SUBJECT: ISSUANCE OF AMENDMENT NO. 23 TO FACILITY OPERATING LICENSE NO. NPF-41 AND AMENDMENT NO. 13 TO FACILITY OPERATING LICENSE NO. NPF-51, FOR THE PALO VERDE NUCLEAR GENERATING STATION, UNITS 1 AND 2, RESPECTIVELY (TAC NOS. 64676 AND 64677)

Amendment No. 23  
License No. NPF-41

ENCLOSURE TO LICENSE AMENDMENTAMENDMENT NO. 23 TO FACILITY OPERATING LICENSE NO. NPF-41DOCKET NO. STN 50-528

FIGURE 3.1 - 1A

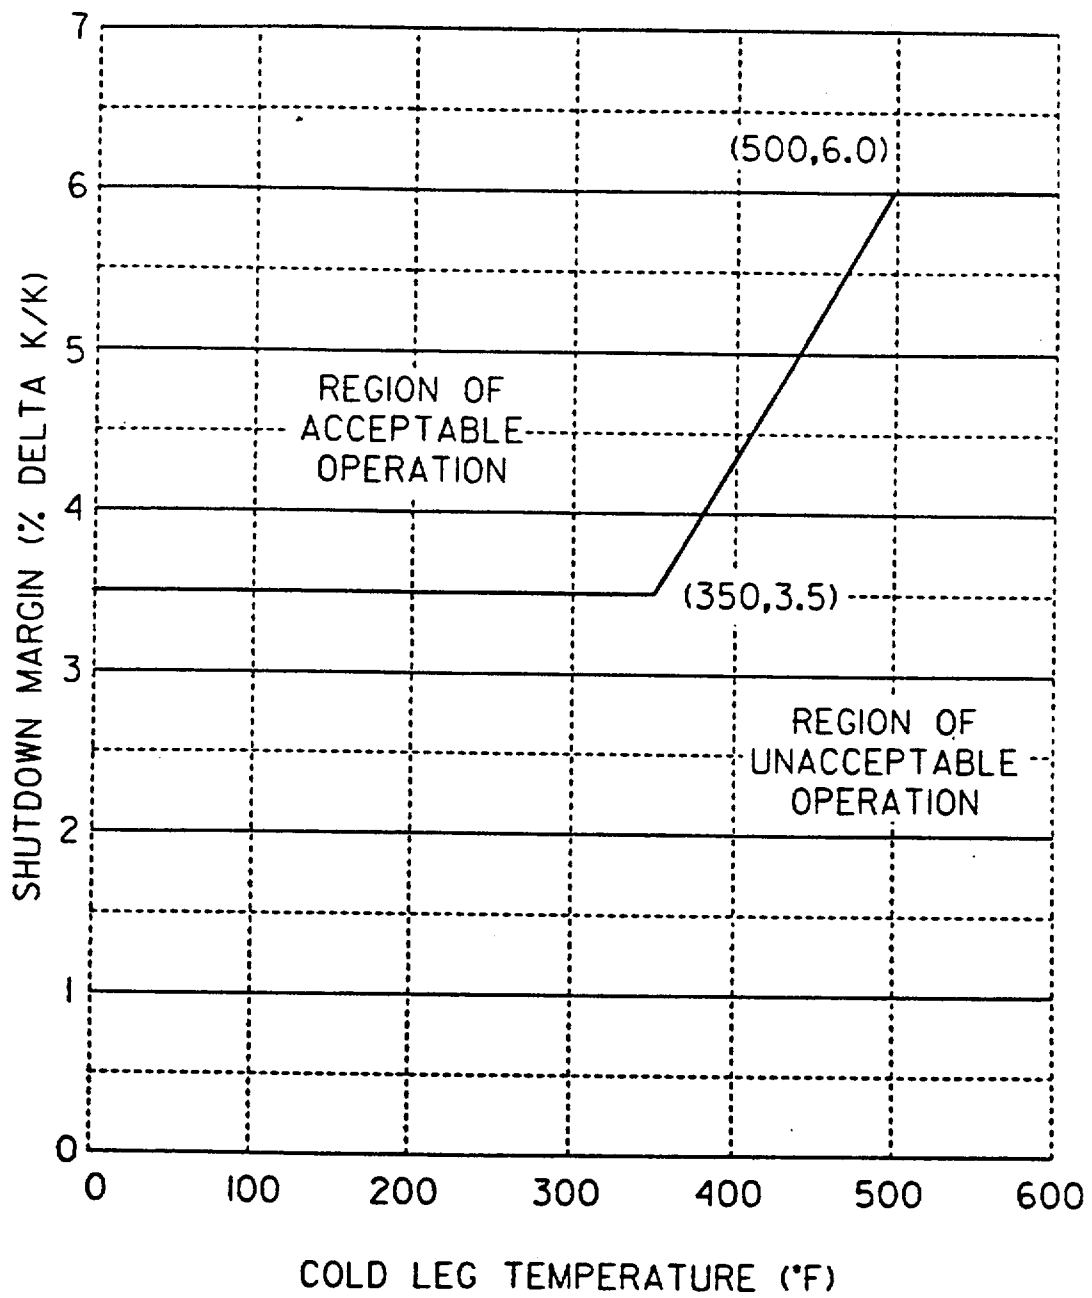
- a. The SHUTDOWN MARGIN shall be greater than or equal to that shown in Figure 3.1-1A, and
- b. For  $T_{cold}$  less than or equal to 500°F,  $K_{N-1}$  shall be less than 0.99.

- a. With the SHUTDOWN MARGIN less than that in Figure 3.1-1A, immediately initiate and continue boration at greater than or equal to 26 gpm to the reactor coolant system of a solution containing greater than or equal to 4000 ppm boron or equivalent until the required SHUTDOWN MARGIN is restored, and
- b. With  $T_{cold}$  less than or equal to 500°F and  $K_{N-1}$  greater than or equal to 0.99, immediately vary CEA positions and/or initiate and continue boration at greater than or equal to 26 gpm to the reactor coolant system of a solution containing greater than or equal to 4000 ppm boron or equivalent until the required  $K_{N-1}$  is restored.

4.1.1.2.1 With any full-length CEA fully or partially withdrawn, the SHUTDOWN MARGIN shall be determined to be greater than or equal to that in Figure 3.1.1A:

The revised Specification 3.1.1.2 would be applicable when any full length CEA is withdrawn and would require that for Modes 1 through 5, the Shutdown Margin be greater than or equal to that given in a new Figure 3.1-1A. This figure specifies Shutdown Margin as a function of cold leg temperature, ranging from 6% delta k/k above 500°F and down to 3.5% delta k/k below 350°F.

FIGURE 3.1 - 1A

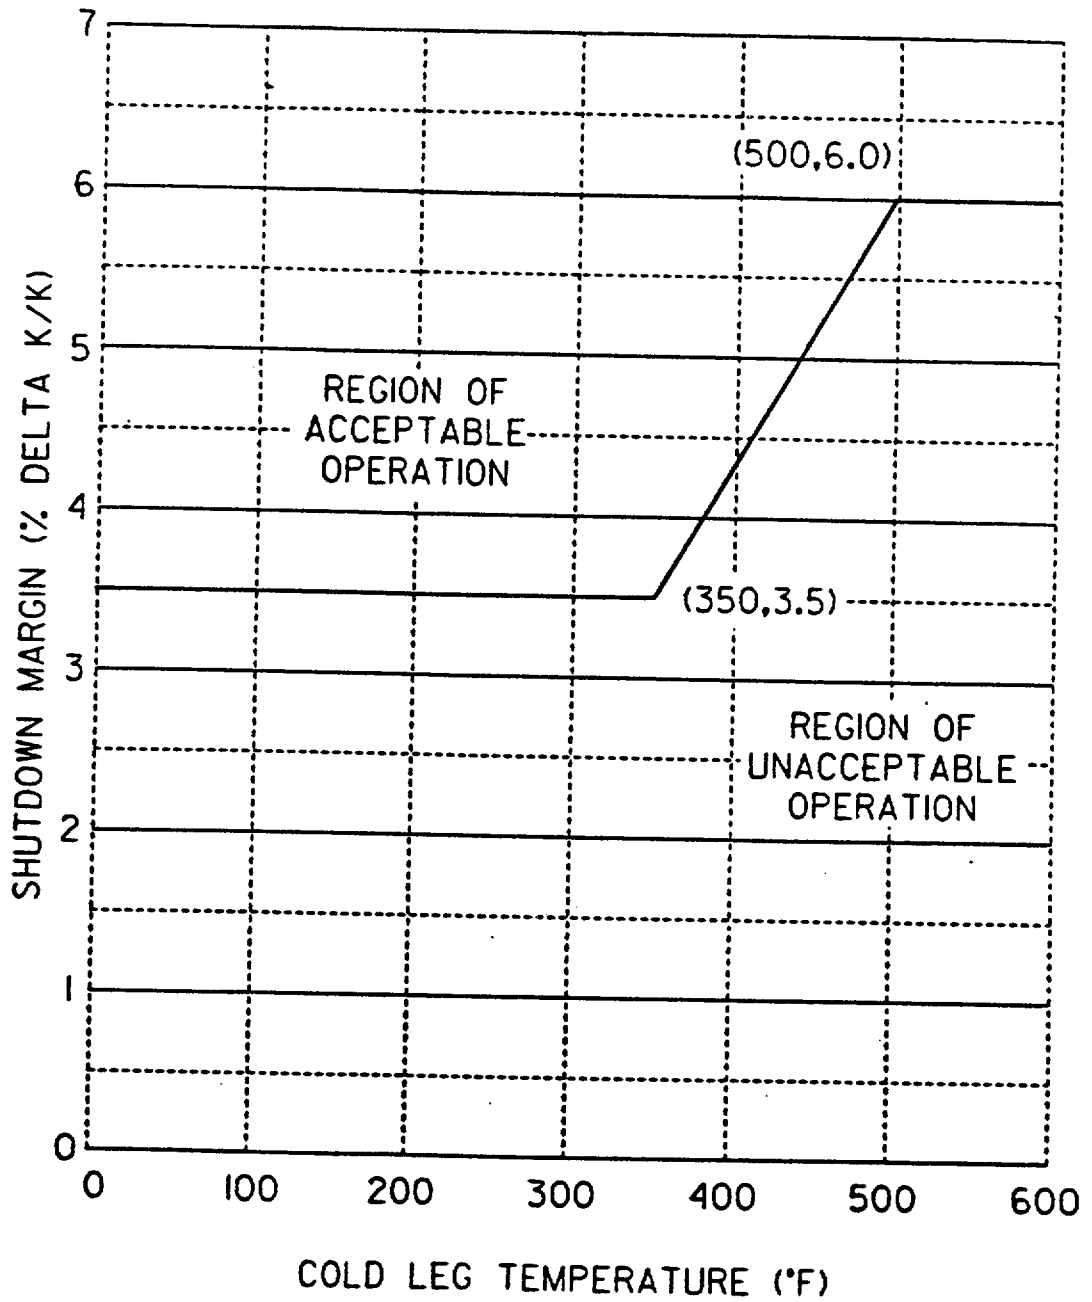
- a. The SHUTDOWN MARGIN shall be greater than or equal to that shown in Figure 3.1-1A, and
- b. For  $T_{cold}$  less than or equal to 500°F,  $K_{N-1}$  shall be less than 0.99.

- a. With the SHUTDOWN MARGIN less than that in Figure 3.1-1A, immediately initiate and continue boration at greater than or equal to 26 gpm to the reactor coolant system of a solution containing greater than or equal to 4000 ppm boron or equivalent until the required SHUTDOWN MARGIN is restored, and
- b. With  $T_{cold}$  less than or equal to 500°F and  $K_{N-1}$  greater than or equal to 0.99, immediately vary CEA positions and/or initiate and continue boration at greater than or equal to 26 gpm to the reactor coolant system of a solution containing greater than or equal to 4000 ppm boron or equivalent until the required  $K_{N-1}$  is restored.

4.1.1.2.1 With any full-length CEA fully or partially withdrawn, the SHUTDOWN MARGIN shall be determined to be greater than or equal to that in Figure 3.1.1A:
